**FINAL
RECORD OF DECISION
LANDFILL REMEDIATION
STUDY AREAS 6, 12, AND 13
AND AREAS OF CONTAMINATION (AOC) 9, 11, 40, AND 41
U.S. ARMY RESERVE FORCES TRAINING AREA
DEVENS, MASSACHUSETTS**

**CONTRACT DACA31-94-D-0061
DELIVERY ORDER 0002**

**Harding Lawson Associates
Portland, Maine**

JULY 1999

Map of Transmissivity Zones

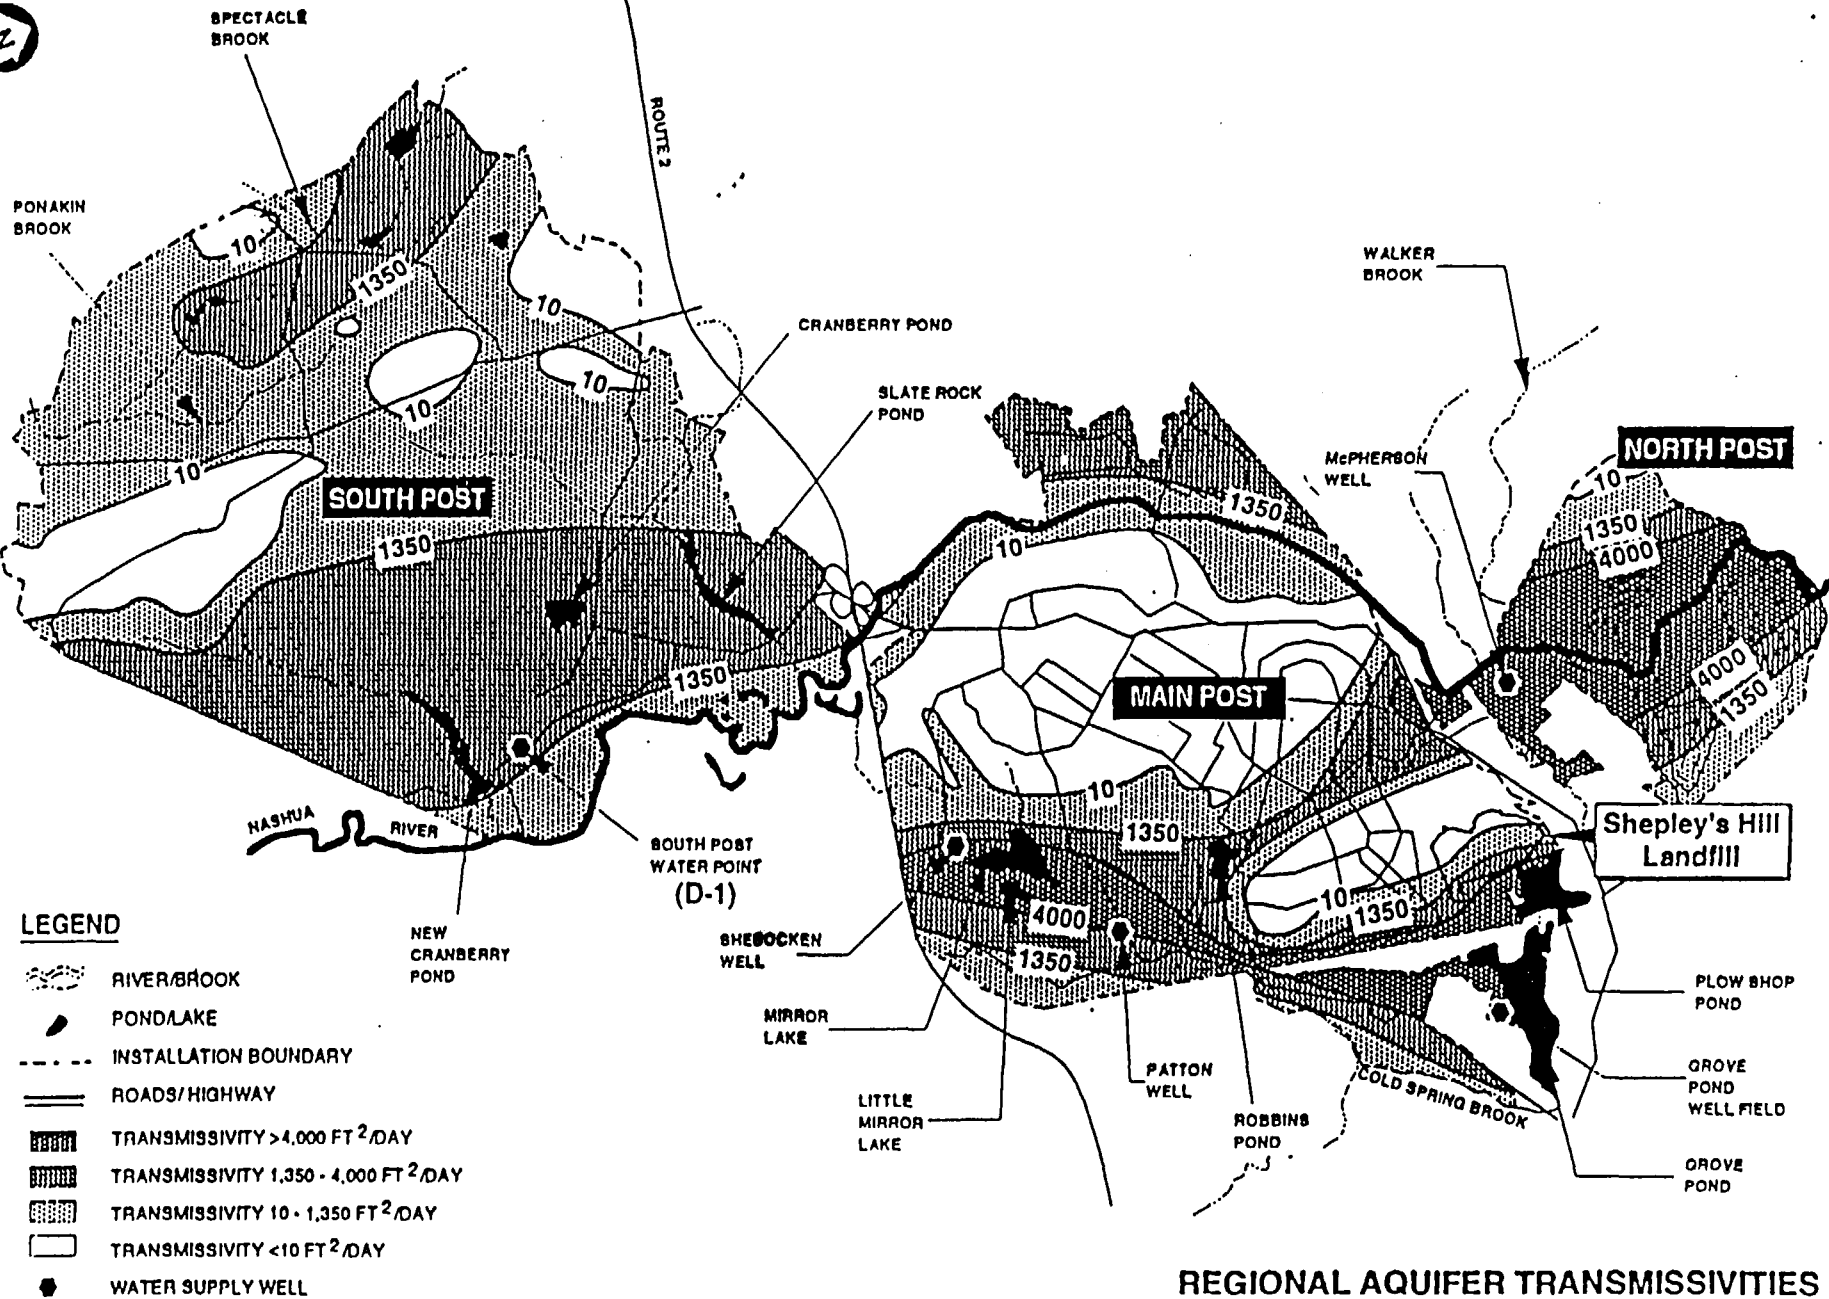
We have already reported to PACE that the location of the proposed Consolidation Landfill is directly on the spot where an extraction well would need to be located to capture ground water flowing to Plow Shop Pond from the south. (This is based on the Army's *Shepley's Hill Landfill Extraction/Discharge System 60% Design, November, 1997*). In that report, the Army concluded (p. 14) that an extraction well could not be placed to the south of Plow Shop Pond because that was where the Consolidation Landfill was to go (Figure 1).

Figure 1.
Overburden Layer

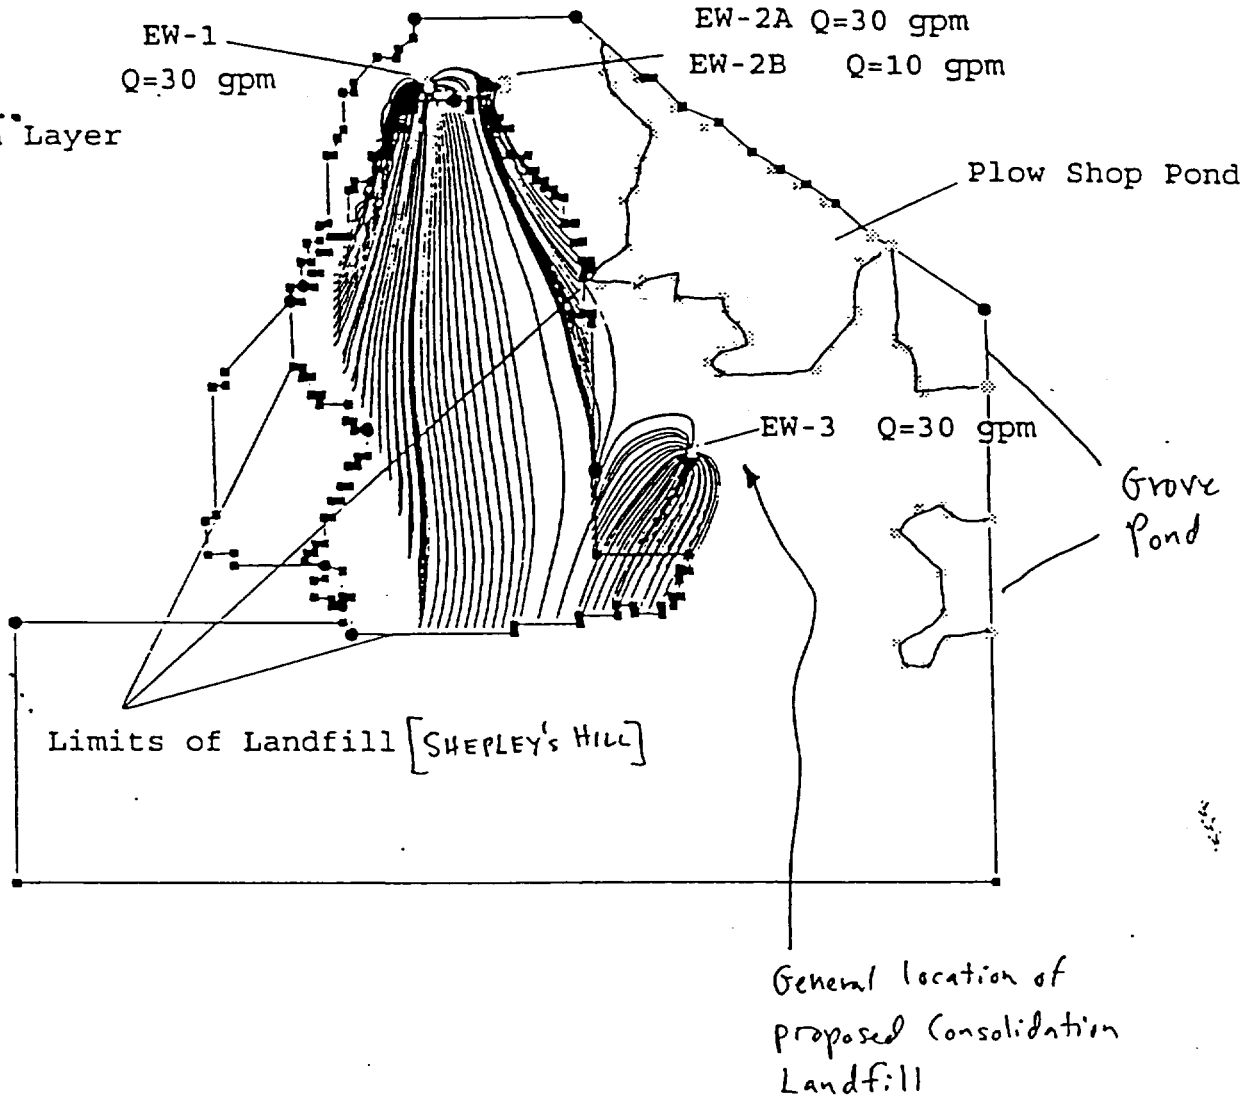
The Consolidation Landfill would cover the location of possible extraction well EW-3. It would then not be possible to capture any contaminated ground water leaking from a future Consolidation Landfill.

General map of Shepley's Hill Landfill and Plow Shop Pond.
Potential locations of extraction well, pipeline, engineered
barrier, and treatment facility to clean up arsenic contaminated
ground water.

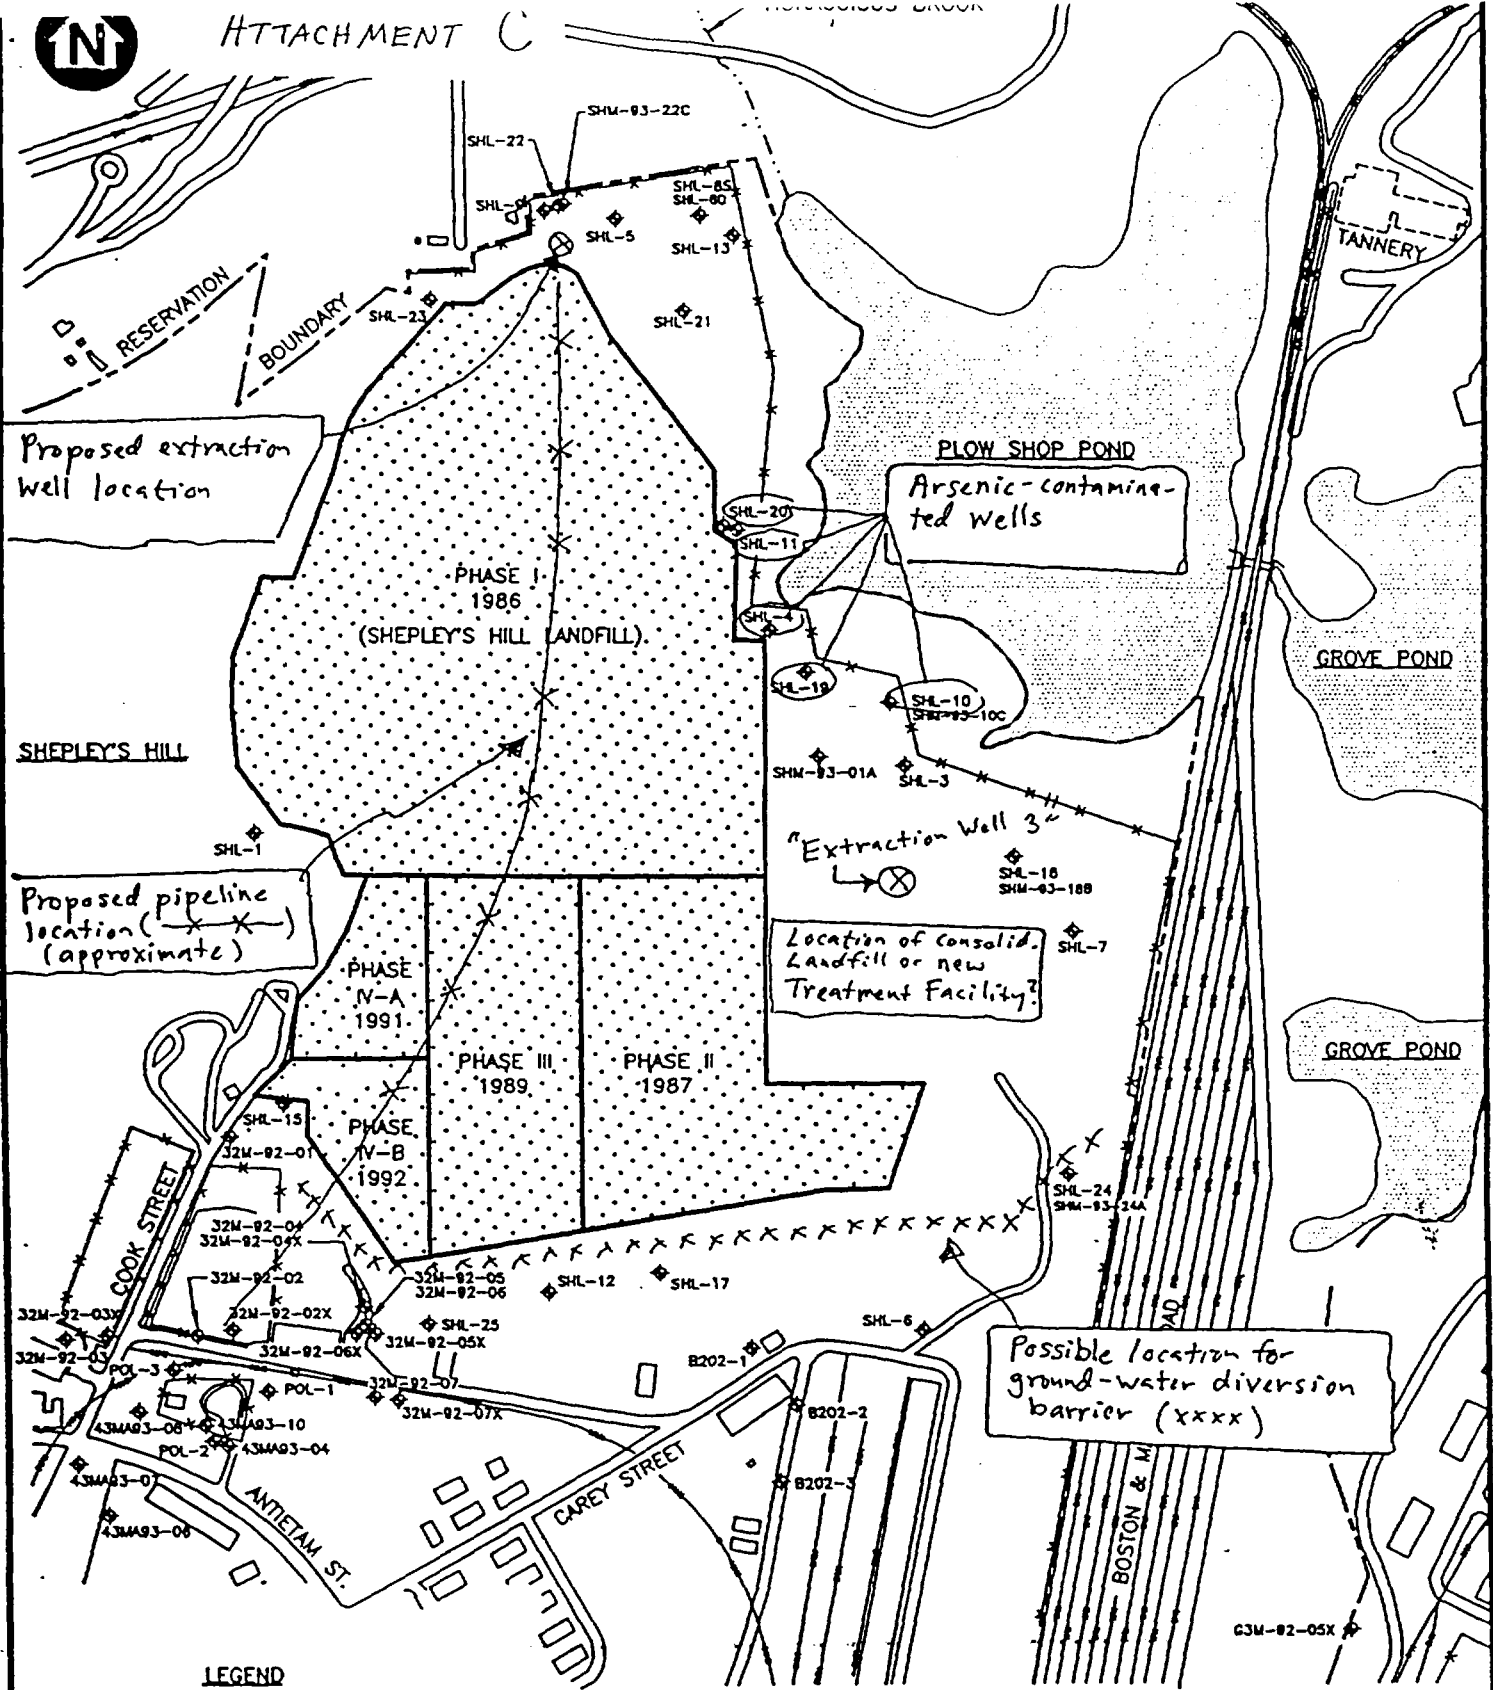
Furthermore, remedial work on Shepley's Hill Landfill may also interfere with the siting of the Consolidation Landfill. One way to prevent ground water from flowing underneath SHL is to build an "engineered barrier" to divert ground water away from SHL. This could be a wall of bentonite slurry or interlocking sheet piling from the bedrock to the ground surface, across the length of the southern end of SHL (Figure 2).
